**DEFENSE NUCLEAR FACILITIES
SAFETY BOARD**

Staff Issue Report

SUBJECT: Erosion/Corrosion Wear Allowances, Waste Treatment and Immobilization Plant

Figure 1. Comparison of experimentally determined wear rate data based on depth measurements with the WTP design basis wear rate for vessels with pulse jet mixers.

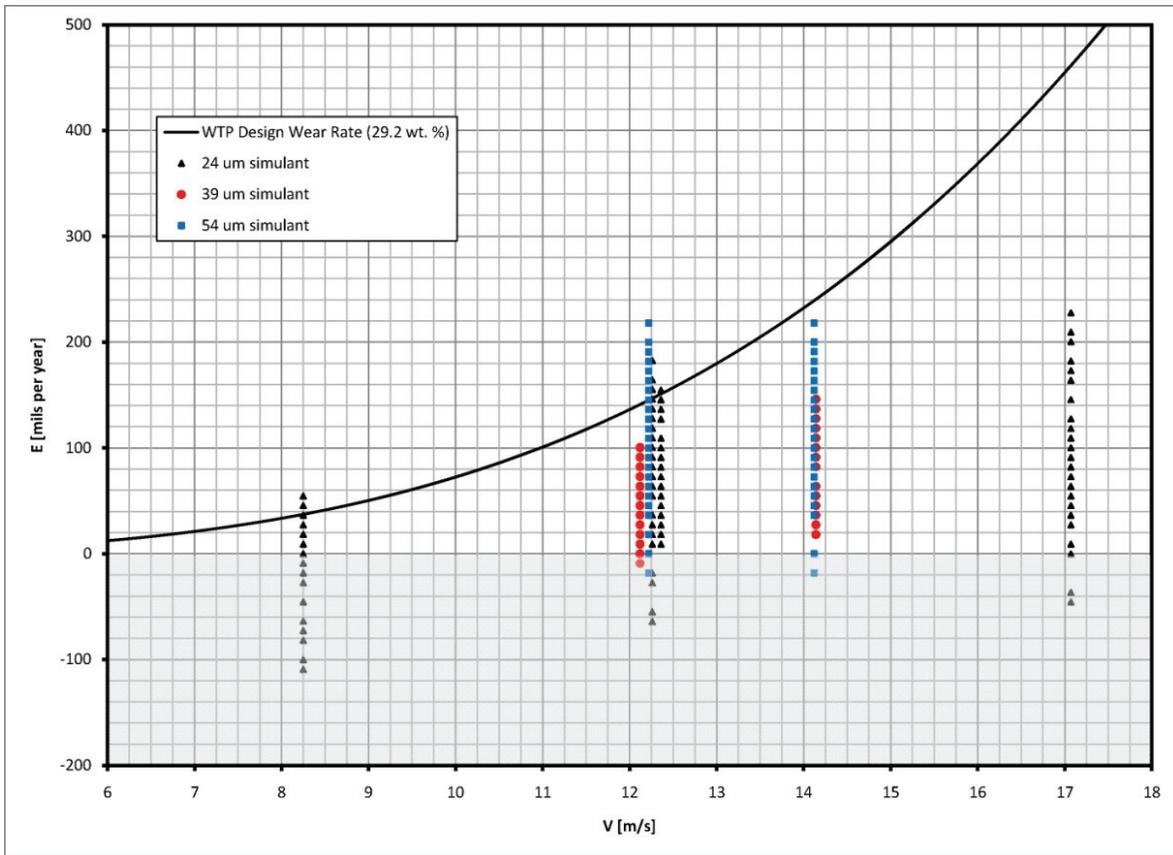
Measured Wear Is Higher Than Design Wear Rate—Figure 1 shows a subset of the data collected during the testing to close EFRT Issue M2. The plot shows the measured erosion rate (E) based on depth measurements as a function of velocity (V). Each datum on the plot represents the wear rate derived from depth measurements made at one of thirteen predetermined locations on each wear specimen. Each wear specimen was exposed to 96 hours of submerged

jet flow that was intended to represent PJM flow against vessel bottoms at a one-quarter scale. Tests were performed using different jet velocities, angles, and flow modes, as well as simulants with different solid concentration and particle size. For simplicity, the plotted data are limited to tests with a solids concentration of 29.2 weight percent and tests conducted with continuous slurry flow perpendicular to the stainless steel wear coupons. The figure also plots the WTP design basis wear rate for a solids concentration of 29.2 weight percent (black curve). The data from the three different test simulants are shown as black triangles, blue squares, and red circles, which correspond to the 24 μm , 39 μm , and 54 μm test simulant, respectively.

A substantial number of the localized wear data measurements for velocities of interest (8–12 m/s) for WTP PJM nozzles and vessel bottoms, including those obtained using the nonbounding but representative 24 μm simulant, lie above the curve that defines the design basis wear rates for WTP vessels and piping. Some of the measured data are 30 percent above the design basis wear rate. Consequently, the relationship used to define design wear rates for the vessels and PJMs does not provide sufficient conservatism.

Test Duration and Measurement Methods Cause Substantial Uncertainty—The short-duration used for the above testing (96 hours) did not cause enough wear to permit accurate measurement of localized wear. In many cases, the resulting wear was close to or less than the accuracy of the instrument used to measure the wear. The result was unreliable measurements and, as shown in Figure 1, large data scatter. The staff analyzed the data and found that the mean difference between independent measurements performed by two different analysts was 0.23 mils with a standard deviation of 0.18 mils (which corresponds to a mean difference and standard deviation of 21.1 and 16.4 in mils per year [mpy], respectively). This error is substantial considering that, as shown in Figure 1, the expected wear for 8 m/s flow is 40 mpy.

As a further indication of uncertainty, data collected at a flow rate of 8 m/s displayed a scatter over a range of -115 mpy to +55 mpy. Data collected at 12 m/s scatter over a range of -65 mpy to +220 mpy. There is no discernable pattern or trend in the data. The experimental data that suggests a negative wear rate (gray region in Figure 1) are physically unrealistic (i.e., indicate that the wear coupons were increasing in thickness during testing).
